# **Stage 1/2 Road Safety Audit Caltragh LRD, Caltragh, Co. Sligo**

**Stage 1/2 Road Safety Audit**  
**Caltragh LRD, Caltragh, Co. Sligo**

<b>Client:</b>	John Walter Burke
<b>Document No:</b>	231304-ORS-XX-XX-RP-TR-13g-001

## Problem No.2: Two Number Main Accesses in Close Proximity

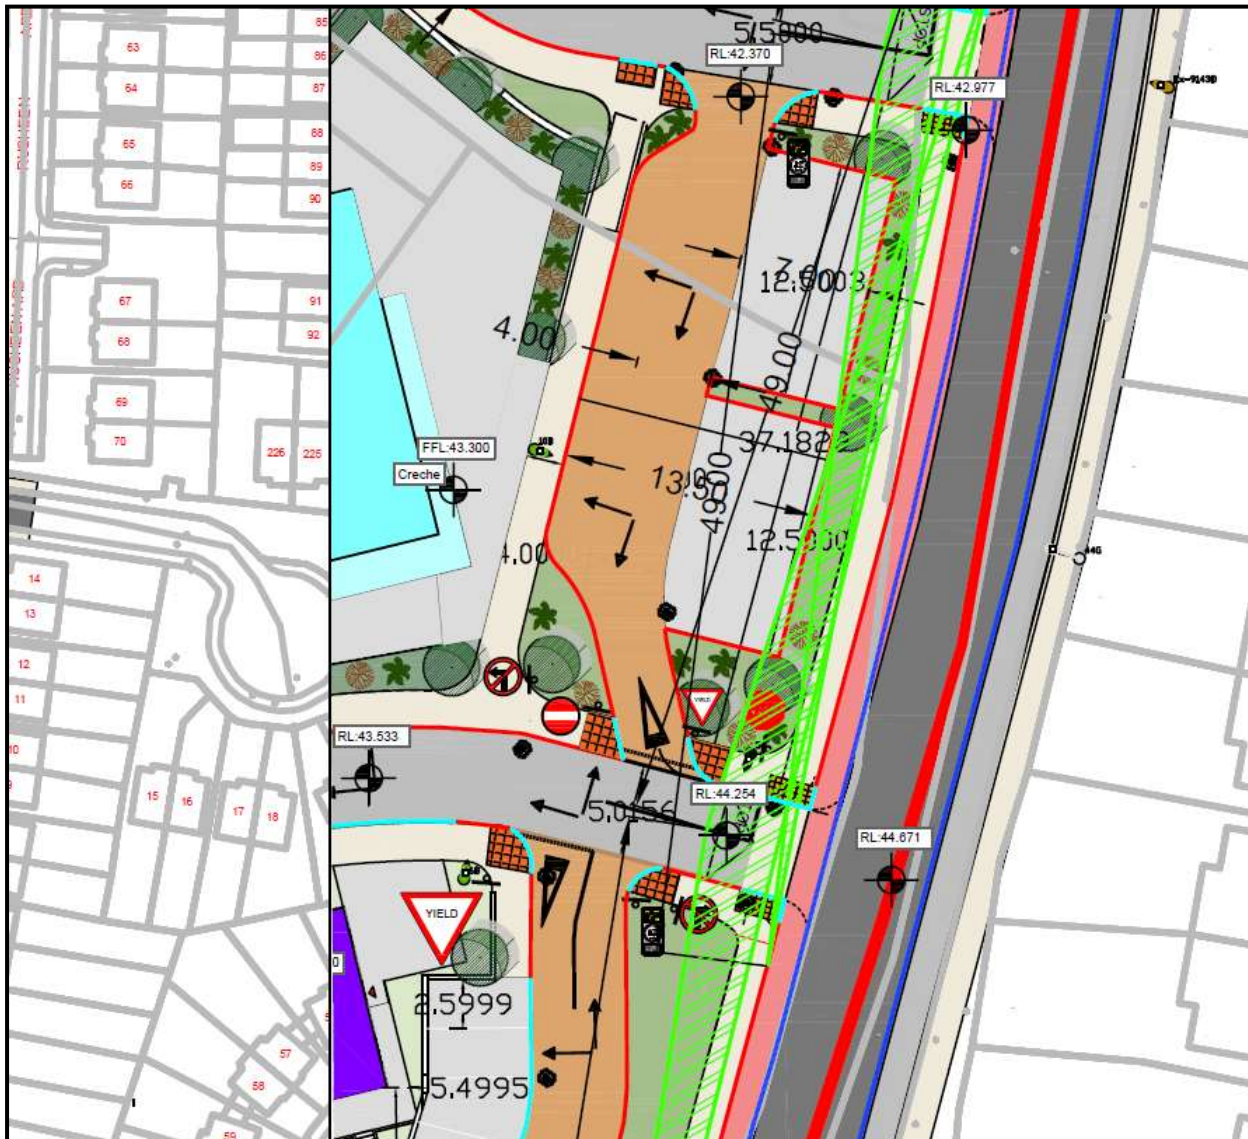
The audit team note that it is intended to provide two main access into the development which is located in close proximity to one another. The audit team are concerned that an additional access point creates additional conflict points for all users and increases the likelihood of potential conflicts among all users.

The design team should remove one of the access points to reduce the safety risk identified.

Problem Reference in Safety Audit Report	To Be Completed by the Designer			To be Completed Audit Team Leader
	Problem Accepted (Yes/No)	Recommendation Accepted (Yes/No)	Alternative Option (Describe) (Only complete if recommendation not accepted)	Alternative Option Accepted by Auditors (Yes/No)
P1	Yes	Yes		
P2	Yes	No	The two entrance proposal allows for a drop off area at the creche. The entrances have been relocated so that the distance from kerb to kerb is approx. 37.5m and lane to lane is approx. 40m.	Yes
P3	Yes	Yes		
P4	Yes	Yes		
P5	Yes	Yes		
P6	Yes	Yes		
P7	Yes	Yes		
P8	Yes	Yes		
P9	Yes	Yes		
P10	Yes	Yes		
P11	Yes	Yes

## Problem No.3: Sightlines

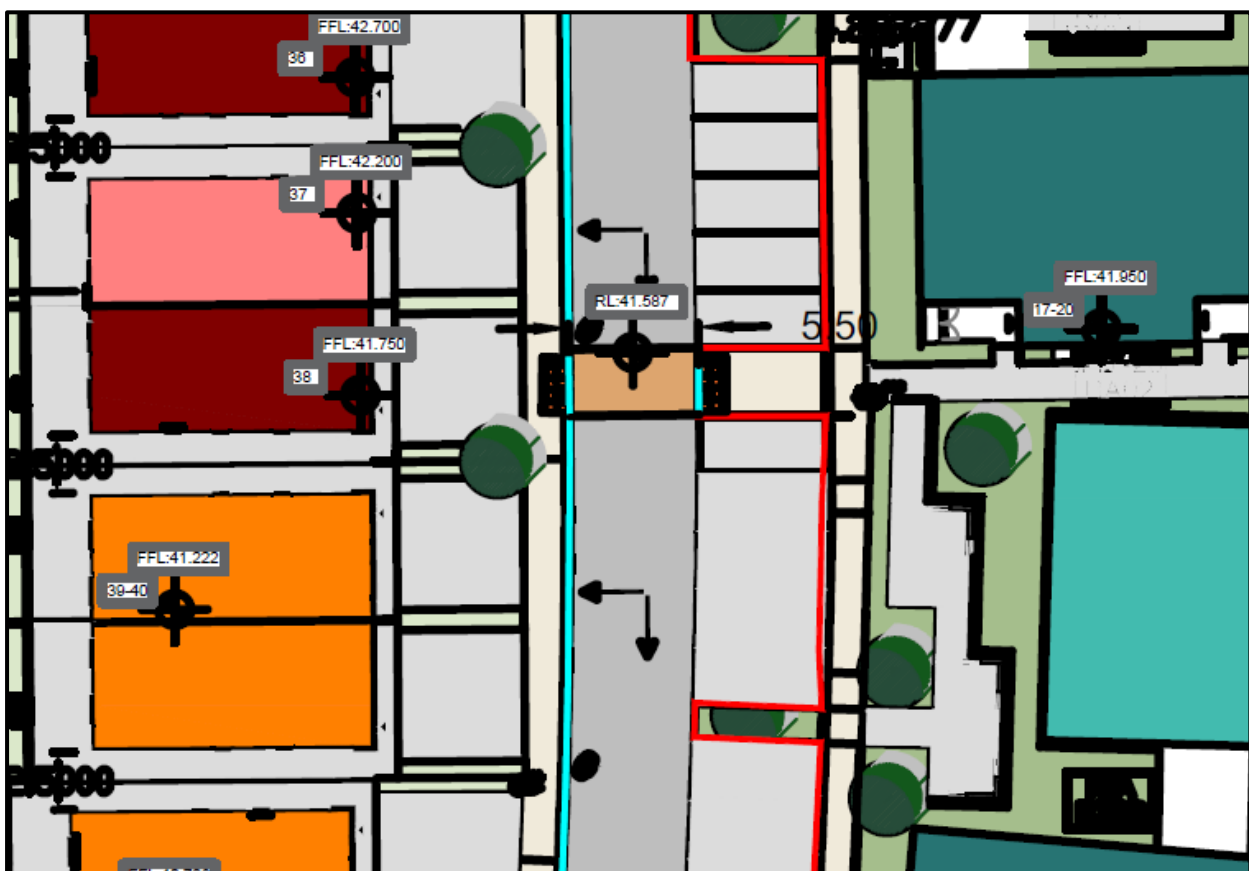
The audit team note that visibility splays at the main access points are shown through landscaped areas which will restrict sightlines considerably. Inadequate sightlines and stopping sight distances could lead to sideswipe, side impact or rear end shunt type collisions resulting in injury to vehicle occupants.

The design team should ensure that sightlines are not restricted by existing or proposed landscaping or street furniture to ensure full unrestricted visibility at the junctions in accordance with appropriate design standards.

## Problem No.5: Pedestrian Permeability

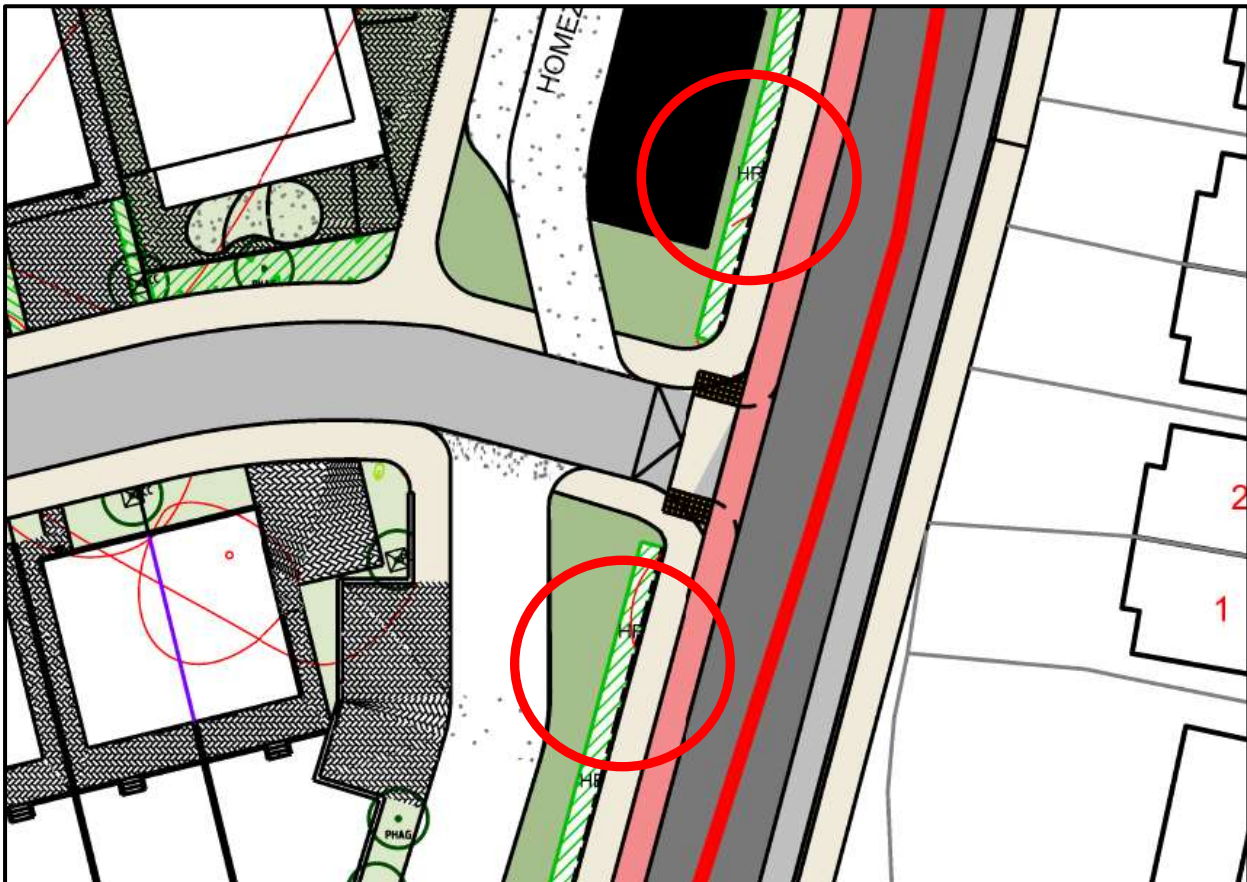
The audit team note from the drawings provided, that there are no details relating to the proposed footpath and kerb levels at entrances throughout the development. Inadequate use of footpath and kerb specifications may lead to undulating or uneven surfaces along the pedestrian paths, resulting in slips, trips and falls and injury for pedestrian with limited mobility.

The design team should consider including the use of bevelled edge kerbs at vehicle accesses along the footpath to allow for level pedestrian paths throughout the site.

## **Problem No.7: Tie in with Caltragh Road Geometry**

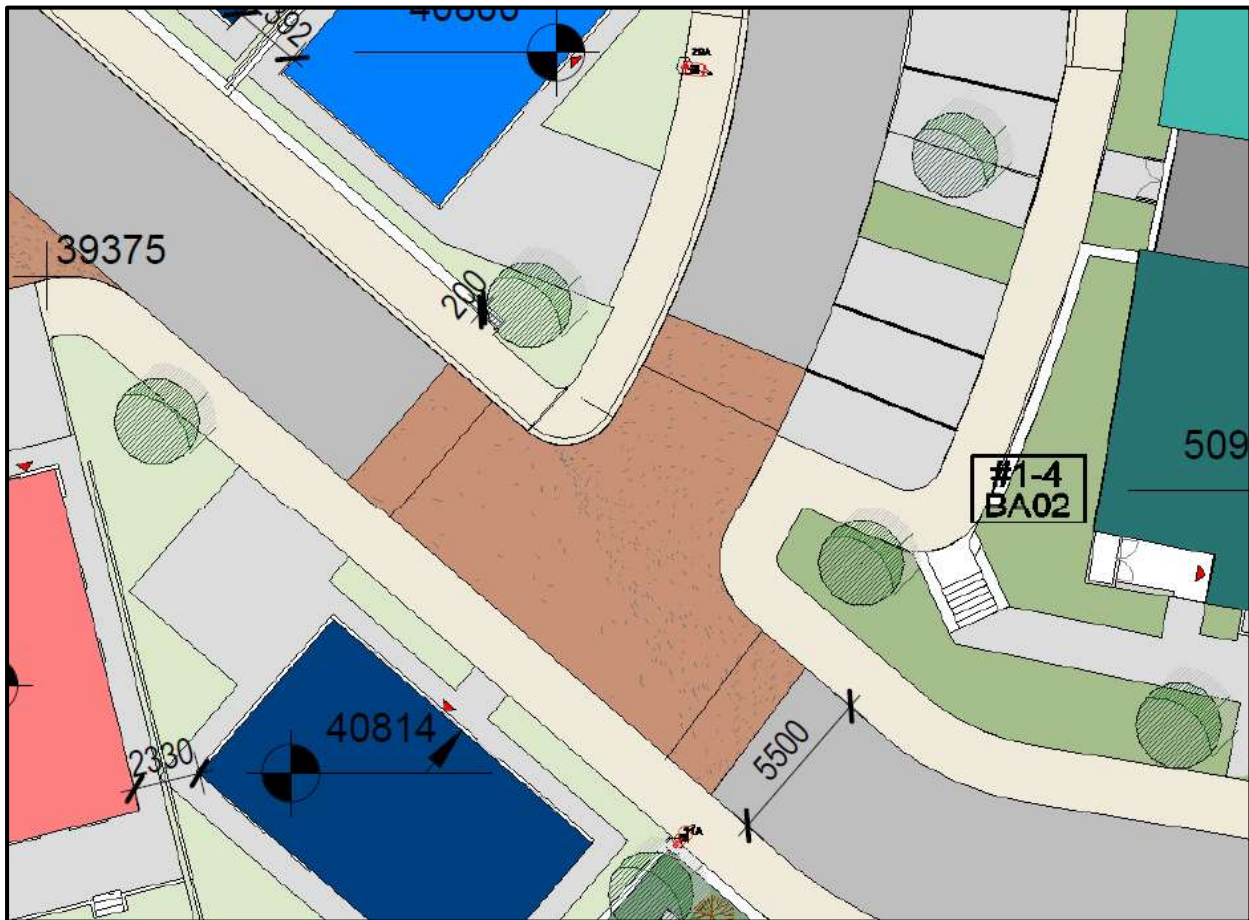
The audit team note that Caltragh Road currently does not have cycle lanes as detailed on the proposed plans and as such the audit team is unsure if the proposed development will tie into the existing arrangement on site or whether upgrades will be carried out to Caltragh Road in advance of opening the development up to traffic. The audit team would have concerns with the limited pedestrian connectivity should the proposed scheme tie into the existing arrangements on Caltragh Road.

The design team should ensure that the proposed development ties in with the proposed arrangements as detailed on the plans. If this is not possible the team should ensure that appropriate measures are provided to ensure appropriate pedestrian connectivity is provided to the existing arrangements on the opposite side of Caltragh Road.
